# Site Accessibility Evaluation

## Americans with Disabilities Act Title II (Public Services: State and Local Government)

### Widefield Park

**Accessibility Evaluation**

Finding 174005 Main Photo

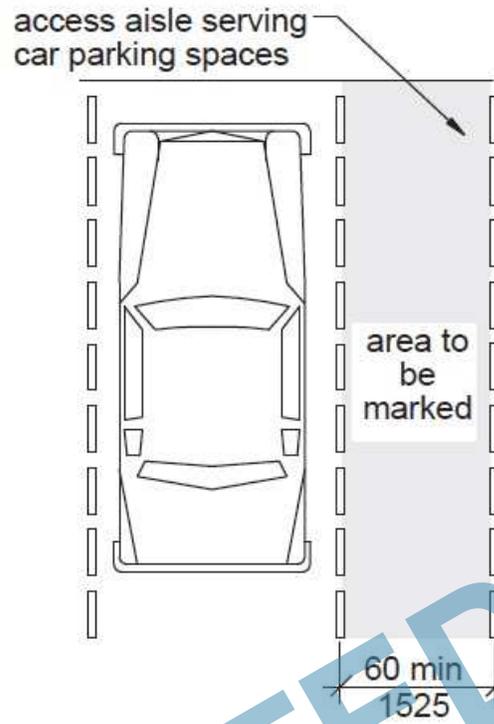
The access aisle is missing at the accessible parking stall.

No accessible aisle

Stripe access aisle in between 2 accessible parking stalls.

Finding 174006 Main Photo

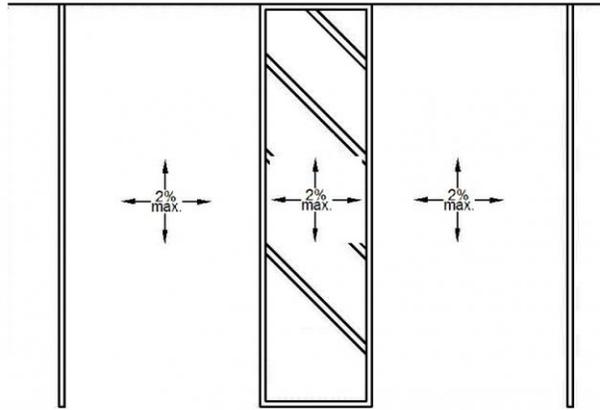
The access aisle for the accessible parking stall contains a built up curb ramp which results in significant slopes greater than 2 percent.

No curb ramp into accessible route

Remove existing curb ramp and build new curb ramp in line with new access aisle to meet 2010 ADA standards.

Finding 174007 Main Photo

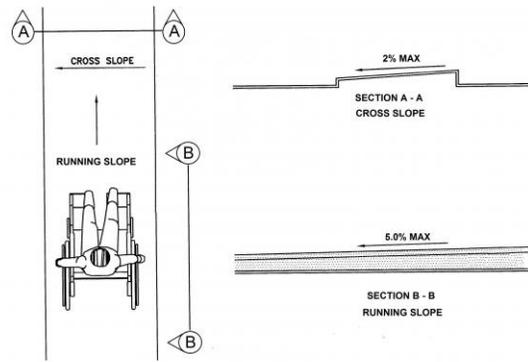
The accessible route between the public bathrooms entrances and the accessible parking on the site contains running slopes greater than 5% and has not been constructed as a ramp (i.e. handrails, wheel guides, etc.).

Certain sections of circulation path up to 8.66% running slope 50ft from parking lot sidewalk

Level path of travel to 5% maximum to meet current ADA standards.

Finding 174008 Main Photo

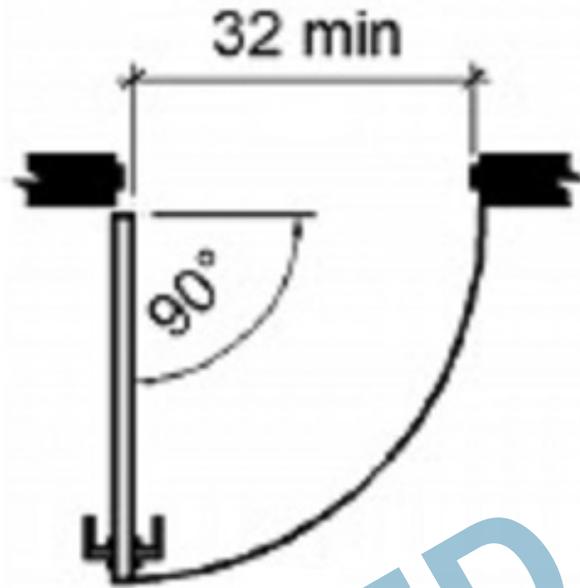
The door opening does not provide at least 32 inches between the face of the door and the opposite stop.

29 inches opening width

Reconfigure door opening to meet compliance. Due to the existing and type of structure, it may be structurally infeasible.

Finding 174086 Main Photo

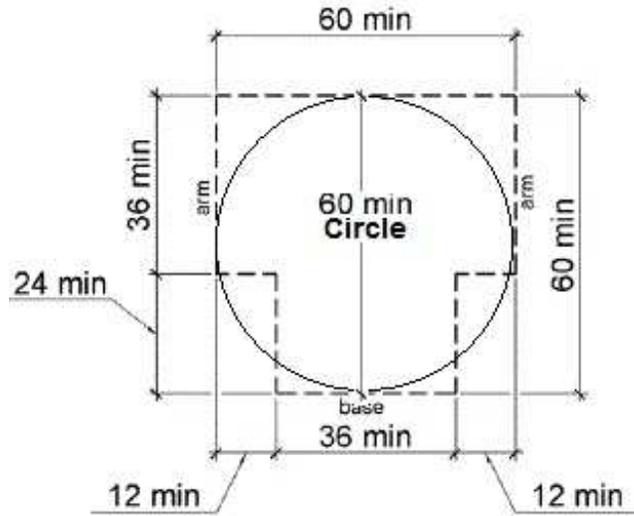
Compliant turning space has not been provided.

54 inches in diameter

Alter toilet, urinal and lavatory to ensure a 60 inch radius is provided.

Finding 174144 Main Photo

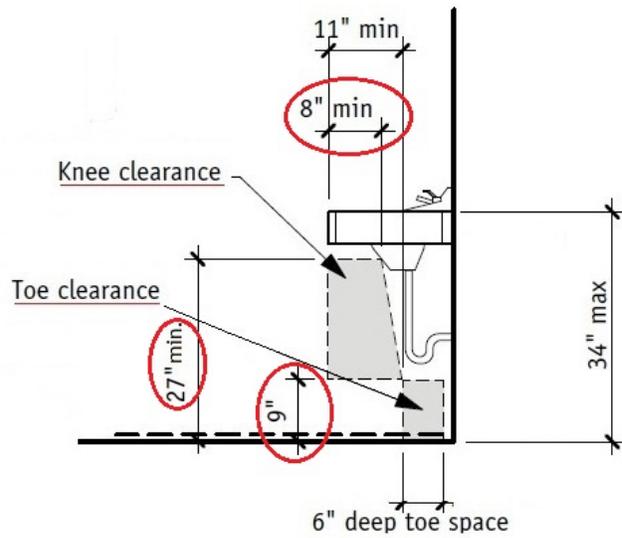
The apron at the sink projects too low to the floor.

Measures only 4 inches back from the front edge

Replace lavatory with one that provides a minimum height from the bottom edge of no less than 27 inches above finished floor and 8 inches minimum in depth for knee clearance.

Finding 174163 Main Photo

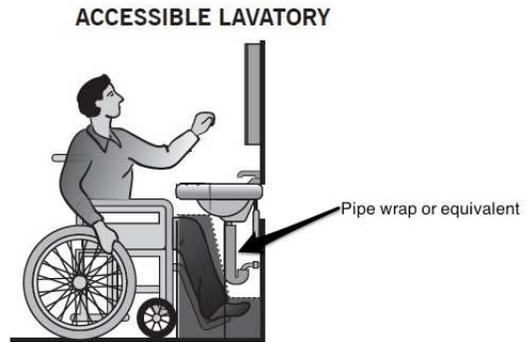
The water and drain pipes under the lavatory are not adequately insulated.

Drain pipes not insulated

Insulate drain pipes underneath lavatory.

Finding 174549 Main Photo

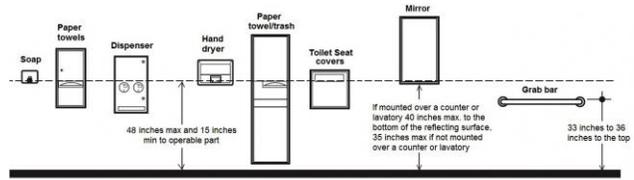
The hand dryer dispenser's operation mechanism is too high off the floor.

50.5 inches from the ground

Lower hand dryer 3 to 4 inches to meet compliance. 48 inches maximum height above finished floor for operable parts (sensor).

Finding 174559 Main Photo

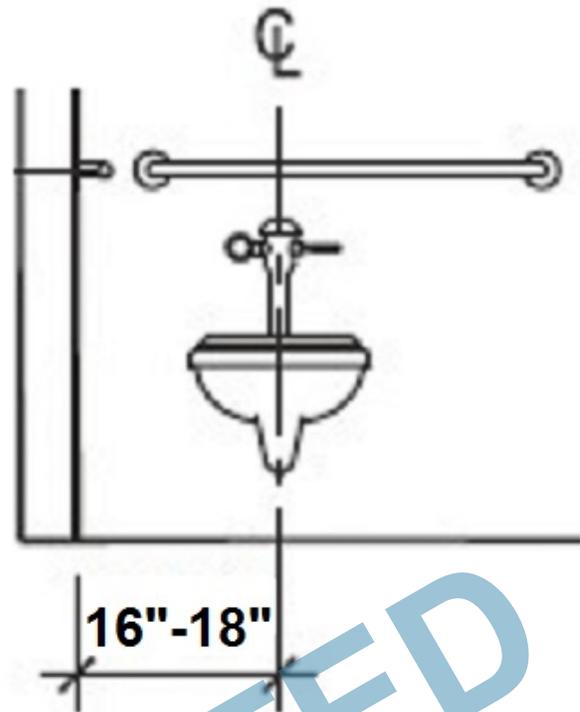
The toilet is not located within the range allowed from the side wall or partition.

18.5 inches from side wall

Re-position toilet between 16 inches minimum and 18 inches maximum from centerline of toilet to side wall. May require plumbing alteration.

Finding 174571 Main Photo

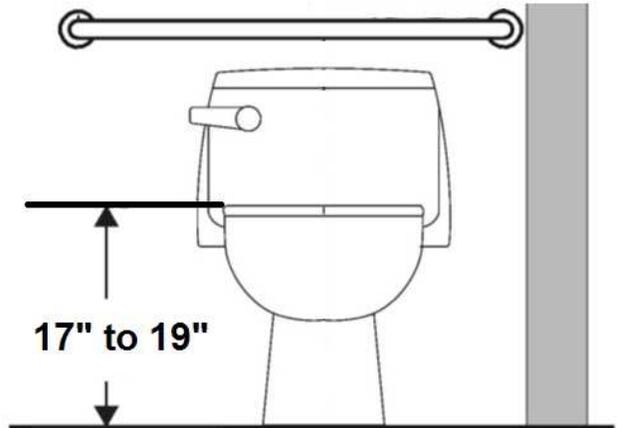
The toilet seat is not located within the range allowed off the floor.

Citation:	As Built:	Budgeting Range:
2010 ADAS Section: 604.4	15 inches	\$150 - \$1,500.00

Adjust toilet height, replace toilet or replace toilet seat with one that will meet the minimum height of 17 inches but no more than maximum height of 19 inches.

Finding 174578 Main Photo

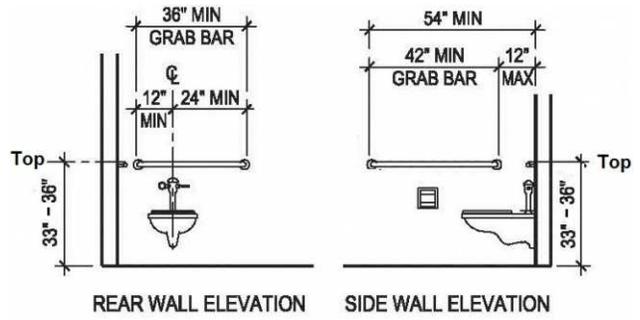
Accessible toilets must have grab bars installed.

Missing grab bars

Install 1 side and 1 rear grab bar at 36 inches maximum above finished floor measured to the top of the gripping surface. Please see finding details for compliant measurements.

Finding 174582 Main Photo

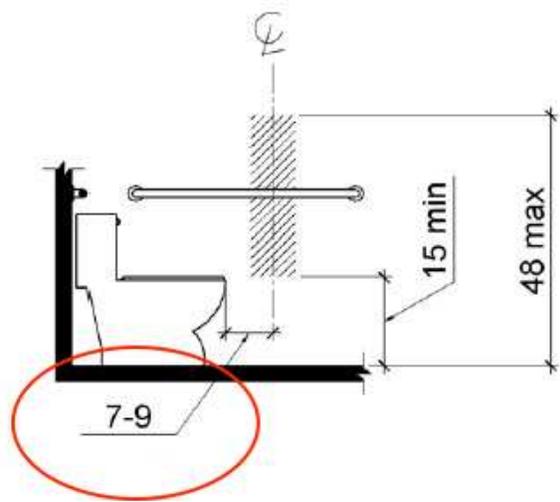
The toilet paper is not installed within the compliant range.

Rear wall

Relocate and ensure toilet paper dispenser is between 7 inches minimum to 9 inches maximum in front of water closet measured to centerline of the dispenser. If toilet paper dispenser is installed above side grab bar ensure there is 12 inches of clearance minimum above side grab bar but no more than 48 inches in height measured from the floor to the center of the paper roll. If installed below grab bar ensure there is 1.5 inches clearance minimum but no less than 15 inches in height measured from the floor to the center of the paper roll.

Finding 174688 Main Photo

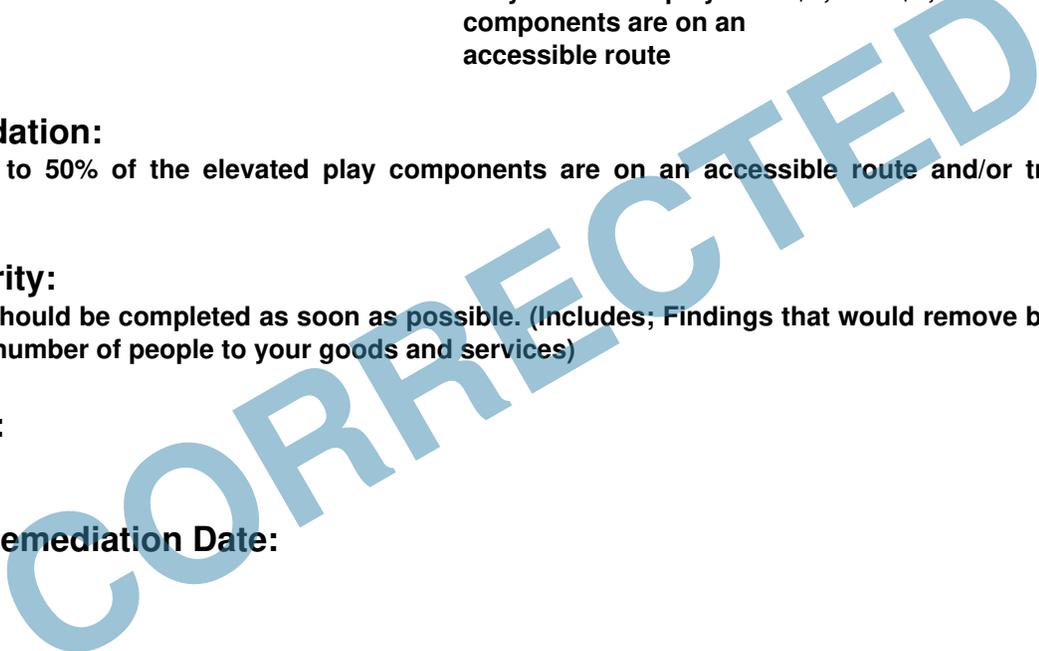
There are not enough accessible elevated play components.

Only 2 elevated play components are on an accessible route

Ensure access to 50% of the elevated play components are on an accessible route and/or transfer system.
